Yarralumla Residents Association Inc

Thank you for the opportunity to comment on the Canberra Brickworks and Environs Planning and Development Strategy.

The Canberra Brickworks and Environs
Planning and Development Strategy
September 2013, including the preferred option

Fig. 2 - Canberra Brickworks and Environs Master Plan 1600 dwellings March 2013 - Blocks 6,9,12 and 15 have been removed in the September 2013 proposed development

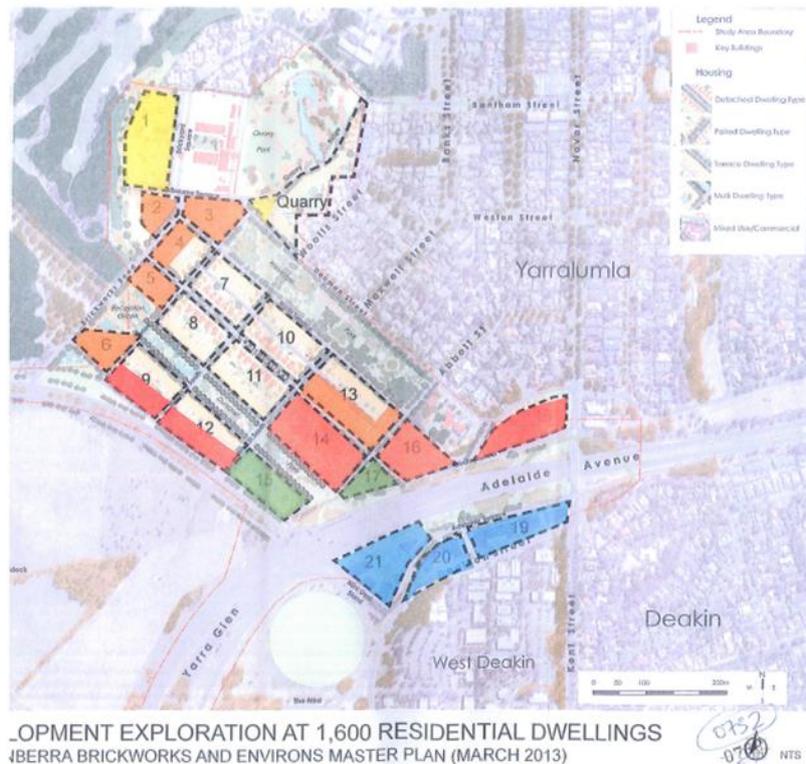
- 5.1 The 2013 proposed development includes a significant area that is labelled for 'Future Stage' (see Fig.1). This has been excised from the previous proposed development put forward by the LDA which included an Interchange. As can be seen from Figure 2, the area marked 'Future Stage' shows that land previously earmarked for 454 dwellings (Blocks 6,9,12 and 15) and a block on the West Deakin side of Adelaide Avenue earmarked for 71 dwellings (Block 21) have been removed from the current proposal.

- 5.3 The consequence has been to increase the number of dwellings in the 2013 Canberra Brickworks and Environs proposed development to reach the 1600 dwellings number. This has increased the density of the development to 47% four to eight storey buildings, as well as reducing the size of Westridge Park by a third since the 2010 proposal.

- 5.4 When the 'Future Stage' area is built, this will add a further 525 dwellings and some 1260 residents. This further increase has not been factored in to any of the assessments in terms of infrastructure, traffic and community facilities.

Fig.7 - Bushfire requirements for site

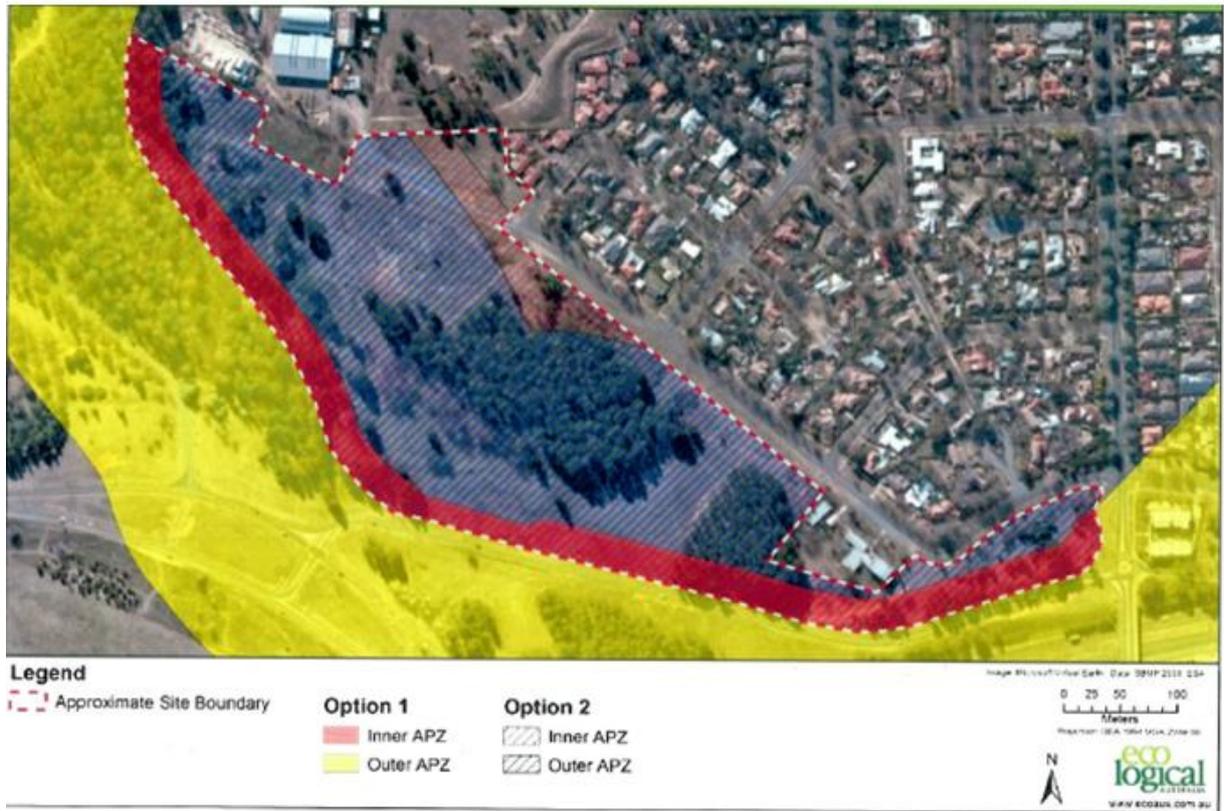
- 14.4 The APZs required for new development in this area as assessed by the National Capital Authority (NCA 2012) are: a 30m wide inner APZ on the western and southern edge; a 20m wide inner APZ where grassland adjoins the boundary on the south-western corner; and a minimum 200m wide outer APZ where forest/shrubland adjoins the boundary along the western and southern edge.

- 14.5 These requirements are set out on Fig.7 (Option1) and it appears that this cannot be achieved with the current proposed development and to do so will reduce the developable area on the site and hence its feasibility. This needs to be taken into account in the assessment of the site.
